No. 1146
ATA Code 24-30

Kit No. 23-3009-1 S

SUBJECT: ELECTRICAL POWER - INSTALLATION OF AN ALTERNATOR OUTPUT CURRENT LIMITER

EFFECTIVITY: BEECHCRAFT B19 Sport 150, serials MB-622 through MB-722 and MB-724 through MB-905; C23 Sundowner 180, serials M-1491 through M-2130; B24R and C24R Sierra 200, serials MC-191 through MC-642.

Figure 1

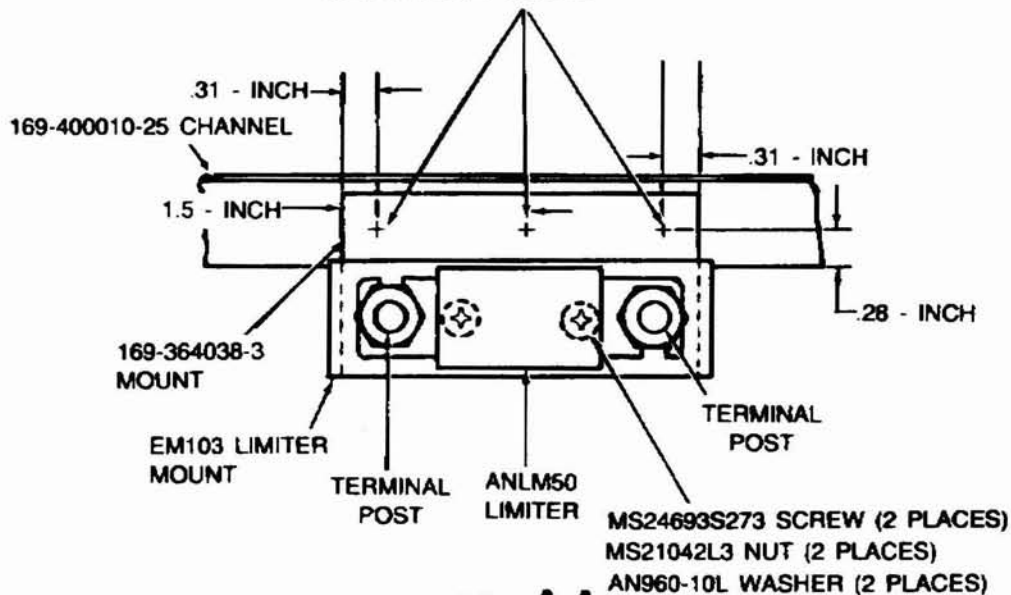
DRILL THREE .128/.133-INCH DIAMETER HOLES AND INSTALL 169-364038-3 MOUNT USING THREE MS 20470AD4-5 RIVETS

4. Dead-end cap and stow the three inch portion of wire remaining in the firewall connector using one of the 324487 wire caps supplied with the kit.
5. Refer to Figure 1 and position the 169-364038-3 mount on the upper channel of the firewall as shown. Drill three .128/.133-inch diameter holes through the lower flange of the channel to match the position of the holes in the mount (see Figure 1, View A-A).

6. Attach the mount to the channel using three MS20470AD4-5 rivets.
7. Install the EM103 limiter mount on the channel mount installed in Step 6.
8. Locate and cut a .75-inch diameter hole in the firewall as shown in Figure 1.

Figure 2

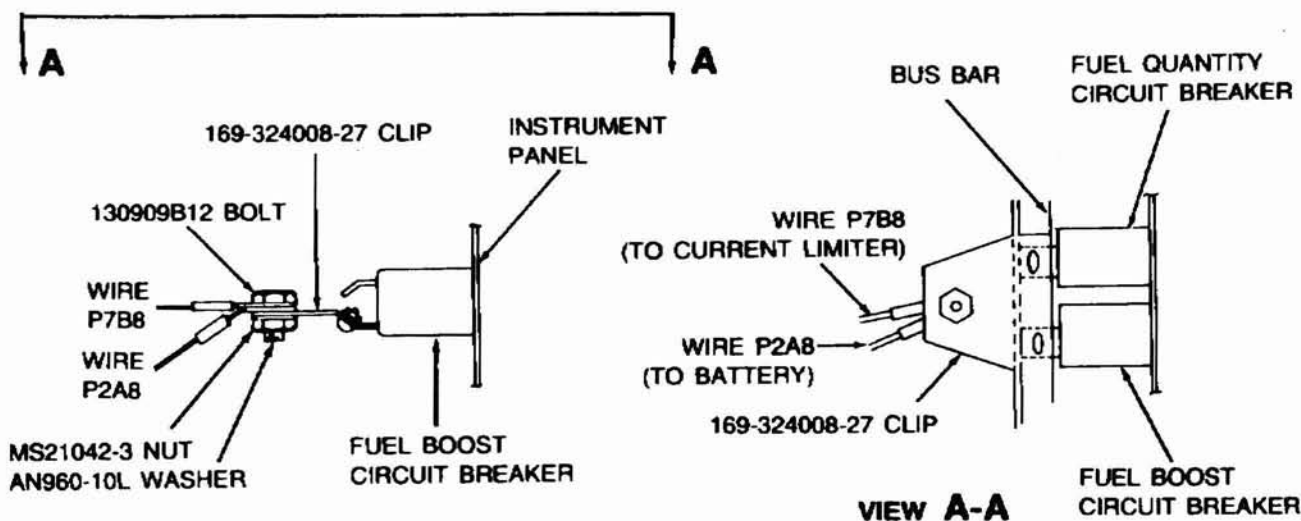
20. Install the 169-324008-27 clip with the attaching hardware removed when disconnecting wires P7B8 and P2A8 in Step 17 (see Figure 2).

21. Install new wire P7B8 which is contained in the 169-360030-651 harness assembly, and the existing wire P2A8 on the clip as shown in Figure 2.
